**ADVISORY BOARD ON
RADIATION AND WORKER HEALTH**

**SC&A CLARIFYING QUESTIONS FOR FERNALD ISSUES
MATRIX – DRAFT WORKING DOCUMENT**

February 2018

TBD FINDINGS 9 AND 11 AND SEC FINDING 3: RECYCLED URANIUM CONTAMINANT RATIOS (PU, NP, TC)

Figure 1. Chart from 2011 NIOSH Document: Issues Related to RU Dose Reconstruction Draft 01 8-5-11 (NIOSH 2011)

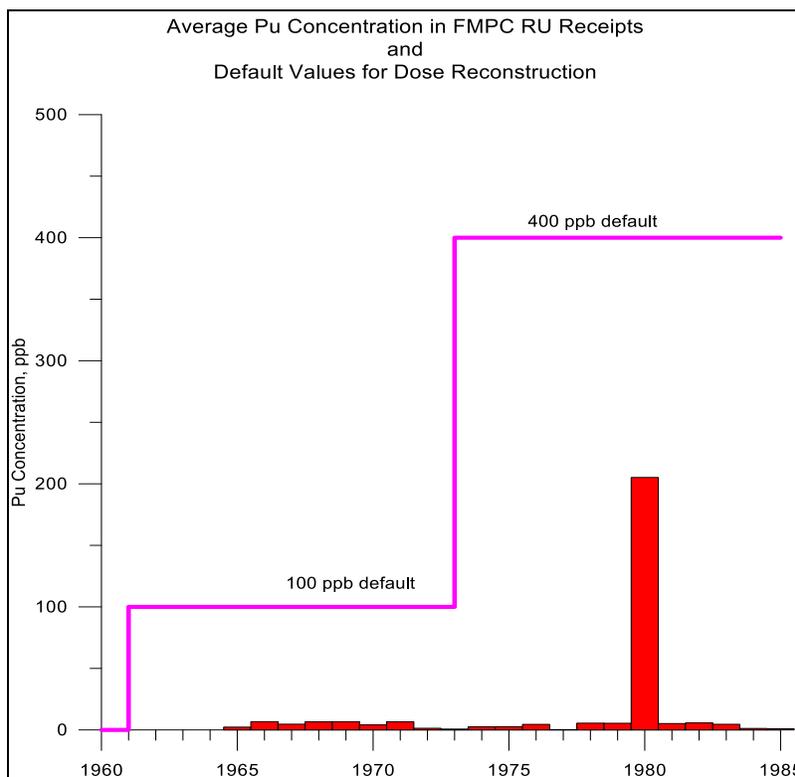
SC&A examined the original Recycled Uranium Project Report (DOE 2000) to identify which recycled uranium lots are applicable to the pre-1973 timeframe. Unfortunately, the original report does not identify a specific date with each lot sample; however, the report does indicate on page 577 that additional information on each lot sample can be provided upon request. It appears that NIOSH made such a request and received additional working documents and database files as indicated on page 3 of NIOSH 2011. In addition, NIOSH 2011 contains a chart which shows average plutonium contaminant ratios as far back as 1965 (this chart is shown as Figure 1, below).

SC&A Clarifying Question 2: How was NIOSH able to determine which lots were processed prior to 1973 as was indicated in Figure 1 (above) as well as the most recent responses contained in NIOSH 2017b?
